February 16, 2007
Subject: **Jackman**
Project No. AIP-3-23-0026-09
Pin No. 13742.00
Amendment No. 1

TYPICAL LEDGER DETAIL

AIRPORT IMPROVEMENTS ~ SRE BUILDING
JACKMAN MUNICIPAL AIRPORT

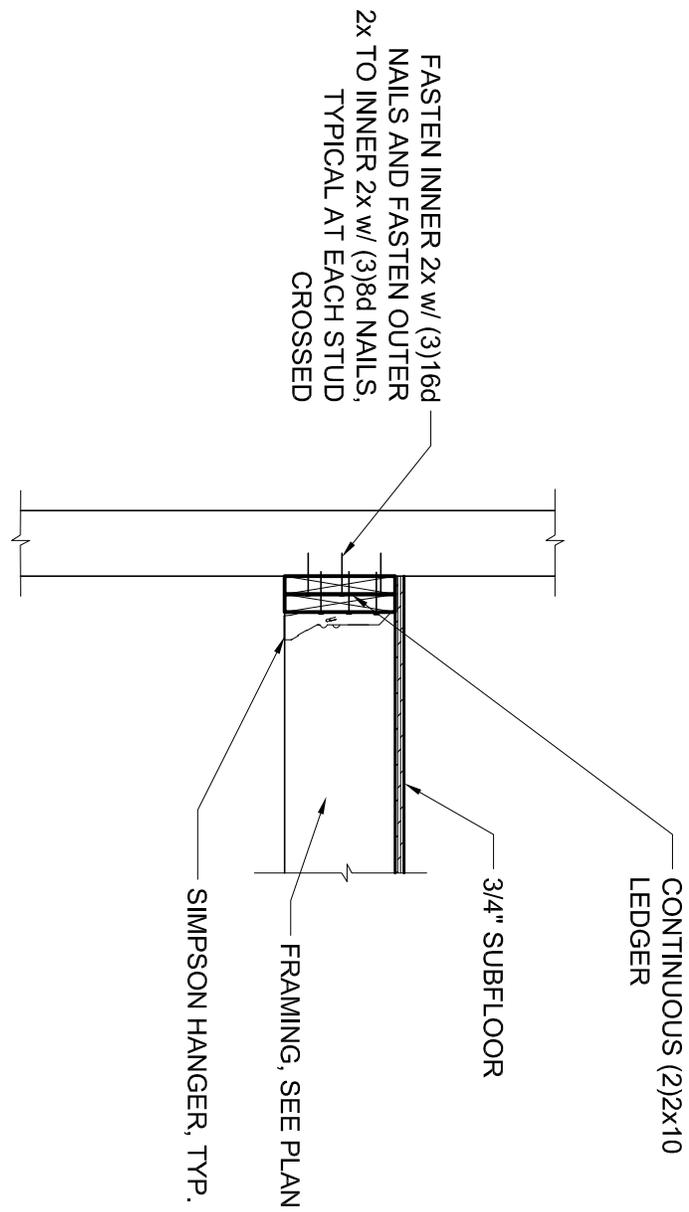
ADD the attached "Typical Ledger Detail" drawing to the Plan sheets.
